SUBJECT: MILLSTONE POWER STATION UNITS 2 AND 3 – NRC SPECIAL INSPECTION
REPORT 05000336/2014011 AND 05000423/2014011

IR 05000336/2014011, 05000423/2014011; 06/02/2014–07/15/2014; Millstone Power Station, Units 2 and 3; Electrical System Response; Event Diagnosis and Operator Performance; Special Inspection to review the May 25, 2014, Dual-Unit Reactor Trip and Loss of Off-site Power; Inspection Procedure 93812, “Special Inspection.”

2.1 Failure to Complete a 10 CFR 50.59 Evaluation for Removal of Severe Line Outage Detection

FIGURE 1 – Millstone Unit 2 and Unit 3 Switchyard

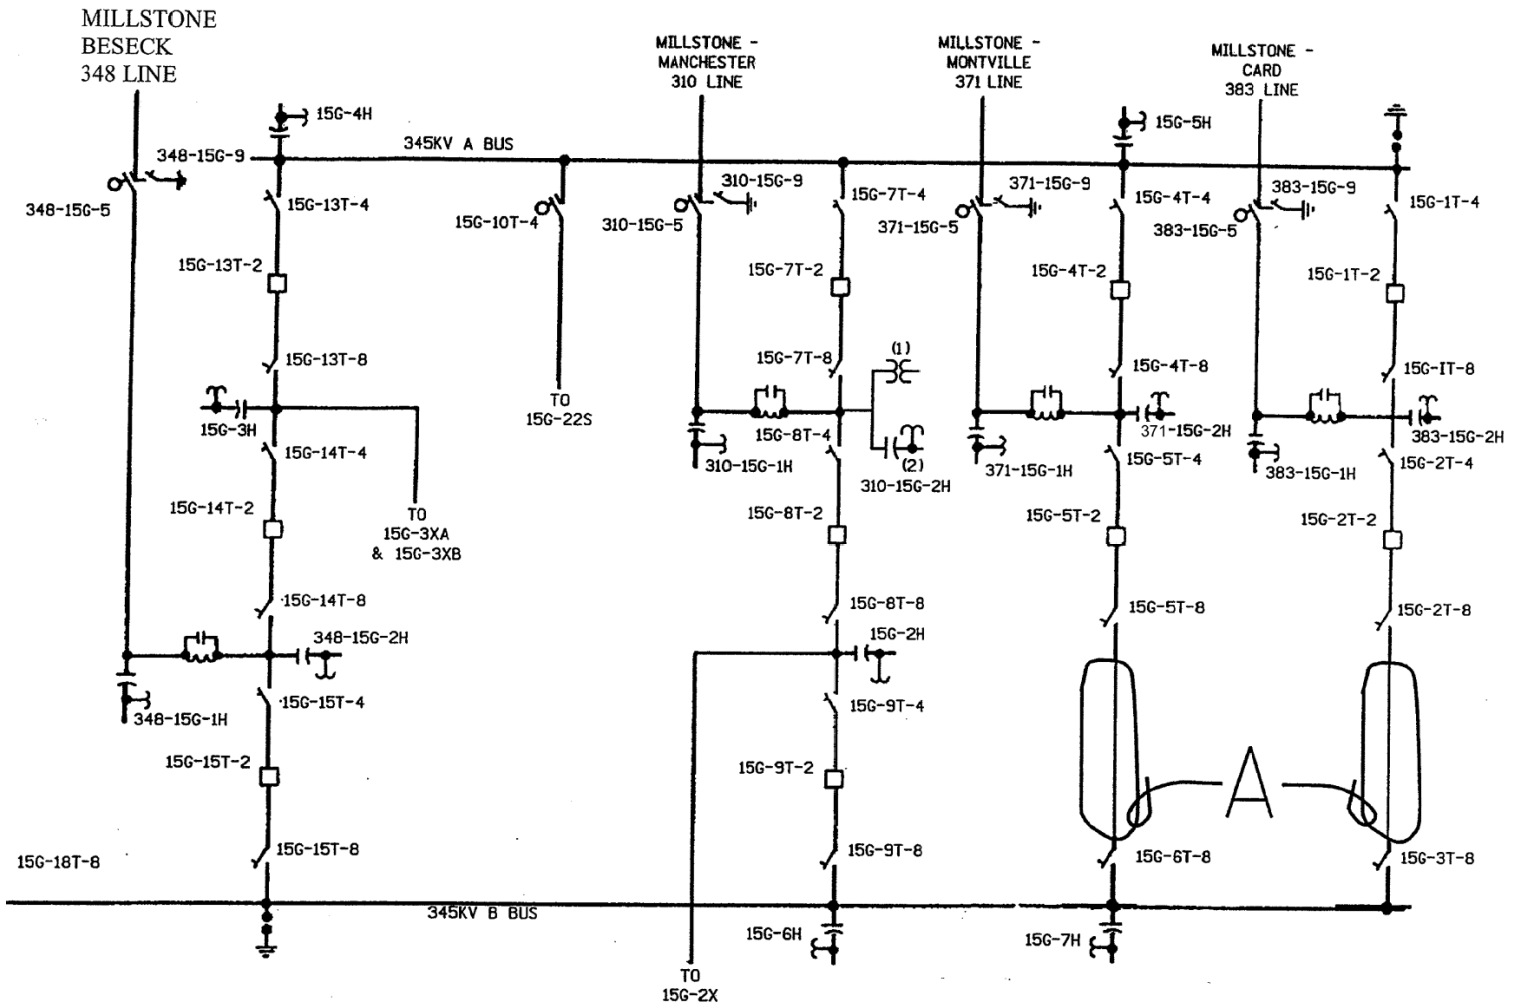
On May 25, 2014, at approximately 0701, while both units were operating at 100 percent power (total output 2166 MWe Gross), Millstone experienced a dual-unit trip following a LOOP (Figure 1 of Attachment 4 provides a diagram of the Millstone switchyard). Prior to the event, one transmission line had been OOS for scheduled maintenance. A phase-to-ground fault on a disconnect switch in the Card substation, located several miles from the Millstone switchyard, caused the automatic isolation of that line. This was followed almost immediately by the loss of a third offsite transmission line through relay operations at the applicable switchyard and grid substations. Finally, because a single offsite transmission line is not capable of carrying the total generation (MWe) of both units simultaneously, this last remaining transmission line was lost (isolated) due to the expected overload condition created by both units power output being carried by a single transmission line. The team determined that if the SLOD SPS had been in service, only Unit 3 would have tripped and Unit 2 would have remained online and providing at least one offsite power source.

On May 25, 2014, at approximately 0701, Millstone Unit 2 and Unit 3 experienced a loss of offsite power while both units were operating at 100 percent power (total output 2166 MWe Gross). The layout of the Millstone switchyard and the four transmission lines emanating from the switchyard are illustrated in Attachment 4, Figure 1.

FIGURE 2 – TRANSMISSION LINE TOWERS - PREVIOUS DESIGN

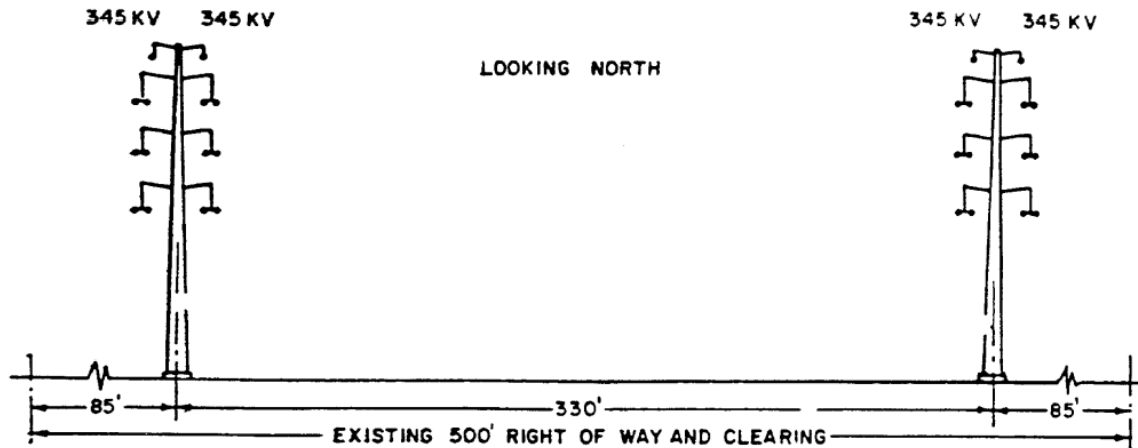
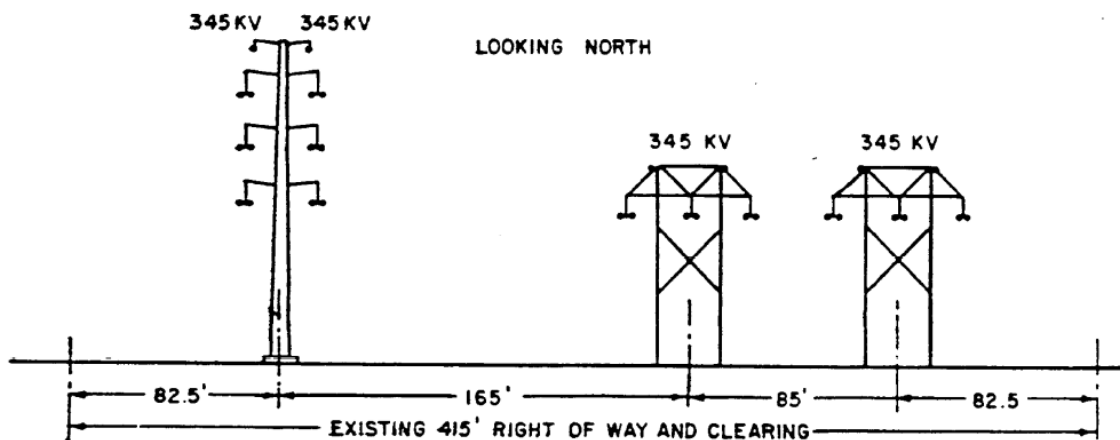
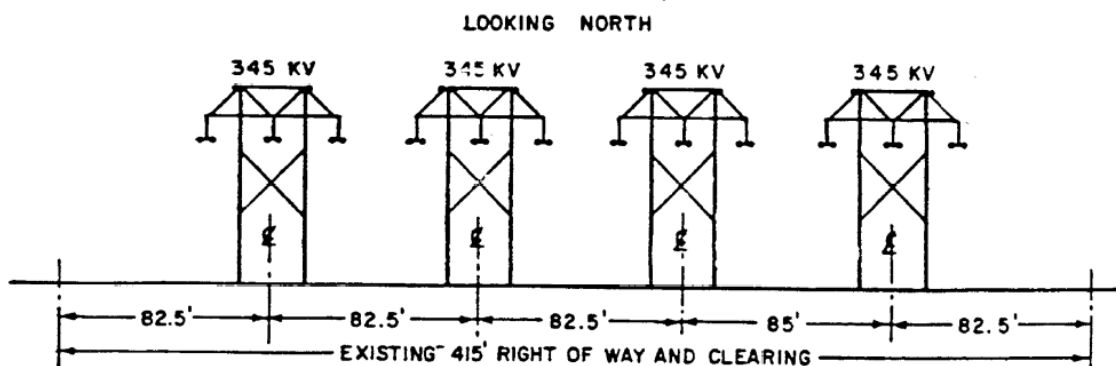
As illustrated in Figure 2 of Attachment 4, prior to December 2012, the four transmission lines from the Millstone switchyard were routed upon two transmission paths consisting of double-circuit steel towers (DCT) (two transmission lines on a common tower) separated by 330 feet, until a point where the lines separated towards their individual transmission line substations.

The team noted the design and licensing bases of both Units 2 and 3 detailed that the DCT configuration caused Millstone to be susceptible to a simultaneous transmission tower fault scenario, either due to a line fault or due to tower collapse. Due to the possibility of this simultaneous loss of two circuits on either transmission tower, coupled with one of the two remaining circuits on the opposite DCT being OOS, Millstone utilized a generator rejection SPS known as Severe Line Outage Detection (SLOD). SLOD was described in Millstone Unit 2 and Unit 3 UFSAR Sections 8.1 and 8.2, respectively, as being credited for meeting the requirements of GDC-17. Specifically, SLOD was designed to protect the last remaining transmission line during potential grid instability conditions, and to ensure the availability of the offsite power to both units. The UFSAR further specified operability requirements for SLOD when one transmission line was taken OOS: (1) to have SLOD fully operational, and limit the net station output ≤ 2500 mega-watt (MW) and limit the output of Unit 3 to the Maximum Allowable Millstone Generation Contingency limit, if applicable, or (2) reduce load to a total station output of ≤ 1750 MW (Gross)/1650 MW (Net) within 30 minutes after the element (transmission line) is removed from service.

FIGURE 3 – TRANSMISSION LINE TOWERS - NEW DESIGN

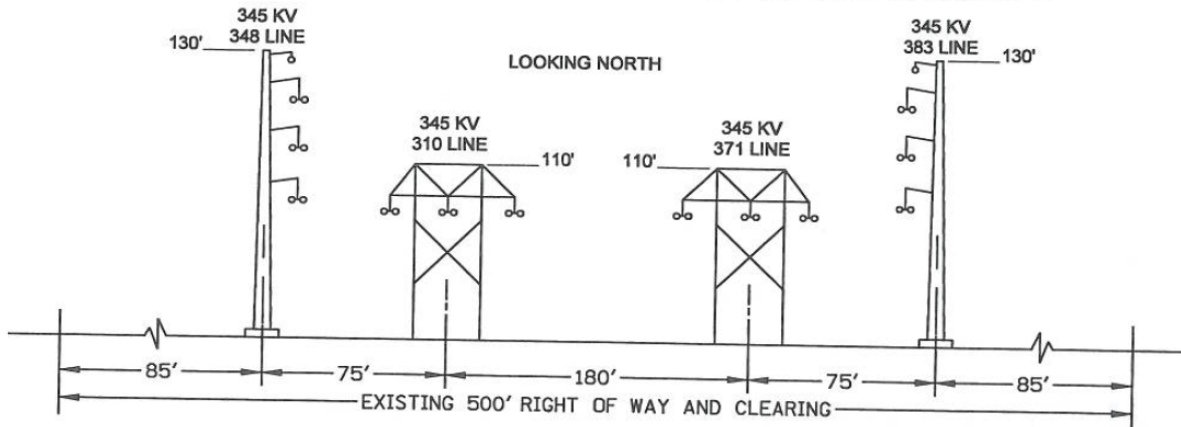
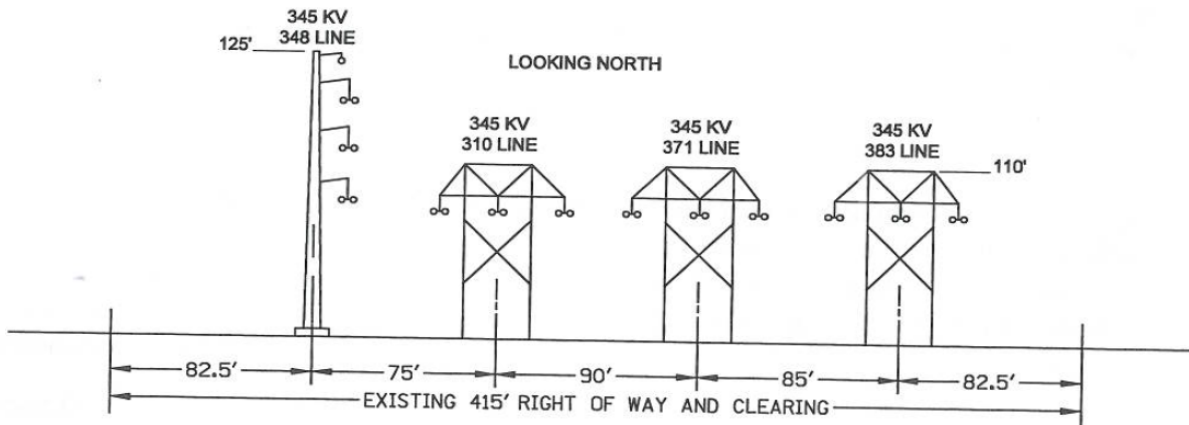
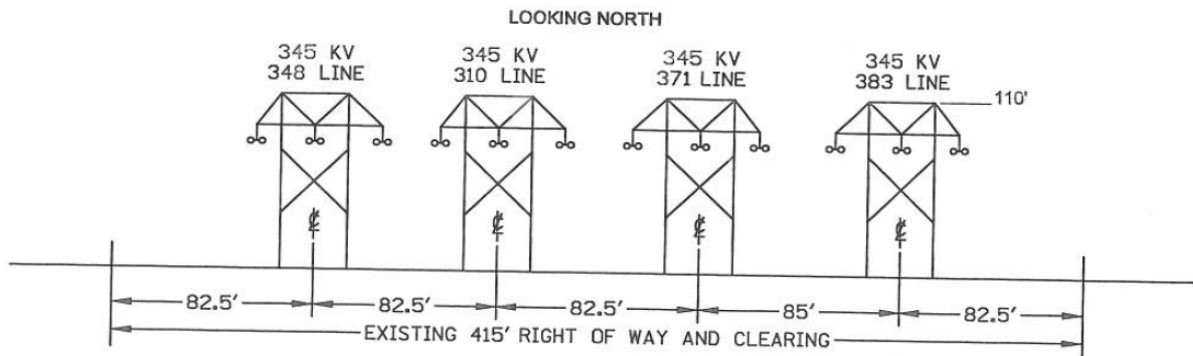
The team identified that in 2012 and 2013, Northeast Utilities, the transmission entity and the owner of the Millstone switchyard, modified transmission circuits at the Millstone switchyard to eliminate the existence of the simultaneous double circuit fault scenarios, which as discussed previously, existed due to the physical placement of two transmission lines on a common tower. This modification by Northeast Utilities installed two new transmission paths going out of the Millstone switchyard. The new offsite transmission line configuration consisted of four, single 345 kV transmission lines each located on a single circuit tower and transmission path, which is illustrated in Figure 3 of Attachment 4, of this inspection report.

The team also determined that the design change did not address the possibility of a mechanical failure of transmission line towers, such as an existing tower falling on the new tower and causing simultaneous failure of two transmission lines. The intent of the design change was to eliminate the simultaneous double-circuit tower fault scenario by separating each of the 345 kV transmission lines on its own tower and its own transmission path. The new design installed two new transmission paths that are located approximately 75 feet (average) from the existing paths within a common right-of-way. The team determined that the 75 feet separation between the existing towers and new towers may not be adequate to prevent a simultaneous double circuit fault scenario if one of the original transmission towers (130 feet tall) falls over onto the newly-installed tower (110 feet). Therefore, the new configuration of the transmission lines is also vulnerable to the same credible fault scenario resulting in loss of three out of four transmission lines. Unit 2 UFSAR Section 8.1.2.1 addressed the original tower heights and the ground clearances between towers. The UFSAR details that the 330 feet separation indicates significant enough clearance to provide adequate physical independence of the transmission lines. The team found that the design change documents did not address this failure mode in the Failure Mode and Effects Analysis section, as required by procedures.
